RE: Incomplete Determination of the 2020 Groundwater Sustainability Plans Submitted for the San Joaquin Valley – Kaweah Subbasin

**STATEMENT OF FINDINGS REGARDING THE  
DETERMINATION OF INCOMPLETE STATUS OF THE  
SAN JOAQUIN VALLEY – KAWEAH SUBBASIN  
GROUNDWATER SUSTAINABILITY PLANS**

**State of California**  
**Department of Water Resources**  
**Sustainable Groundwater Management Program**  
**Groundwater Sustainability Plan Assessment Staff Report**

Groundwater Basin Name: San Joaquin Valley – Kaweah Subbasin (No. 5-022.11)  
Number of GSPs: 3 (see list below)  
Number of GSAs: 3 (see list below)  
Point of Contact: Eric Osterling  
Recommendation: Incomplete  
Date: January 28, 2022

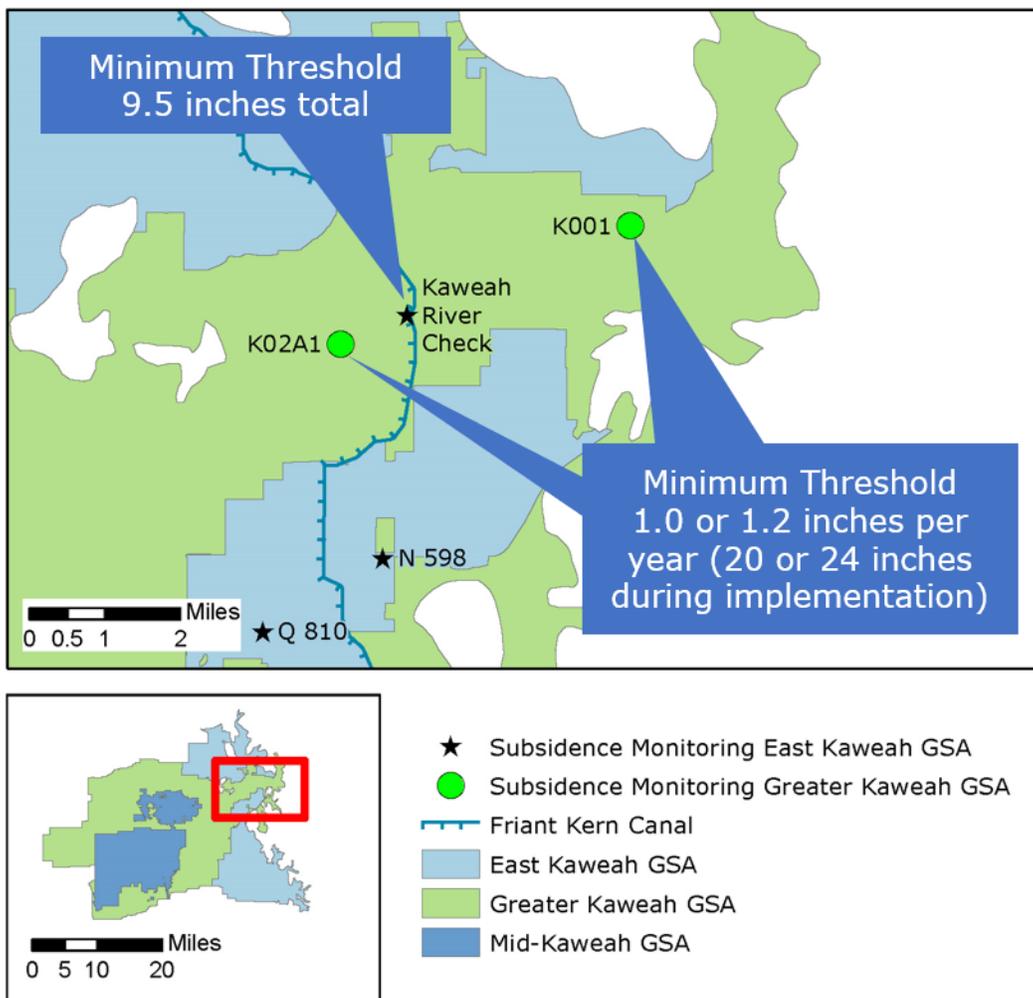
The differences between Greater Kaweah and East Kaweah GSPs creates the potential for inconsistency in groundwater management between the Subbasins GSPs. A portion of the Greater Kaweah GSP area bisects the East Kaweah GSP area in the vicinity of the Friant Kern Canal (see Figure 1).

Greater Kaweah’s subsidence minimum thresholds in this area allow for 1.0 to 1.2 inches per year of subsidence, or 20 to 24 inches cumulatively over the 20-year implementation period. Neither the East Kaweah nor the Greater Kaweah GSPs nor the Kaweah Subbasin Coordination Agreement explain how up to 24 inches of subsidence in the Greater Kaweah area can be accommodated without interfering with the 9.5-inch limit set by East Kaweah to protect the conveyance capacity of the Friant-Kern Canal. The GSPs will need to reconcile this apparent discrepancy. (See Corrective Action 2b.)

- b) Following changes to the GSPs described in Corrective Action 2a, Greater Kaweah also must explain how their minimum thresholds in the vicinity of identified critical infrastructure (i.e., the Friant Kern Canal) will not substantially interfere with the Canal's use (identified by East Kaweah GSA as an undesirable result). Address how the amount of potential cumulative subsidence allowed for by Greater Kaweah's subsidence rates, which currently exceeds the amount identified by East Kaweah that would cause an undesirable result, are compatible or provide revised rates for the eastern portion of the Subbasin that are compatible.
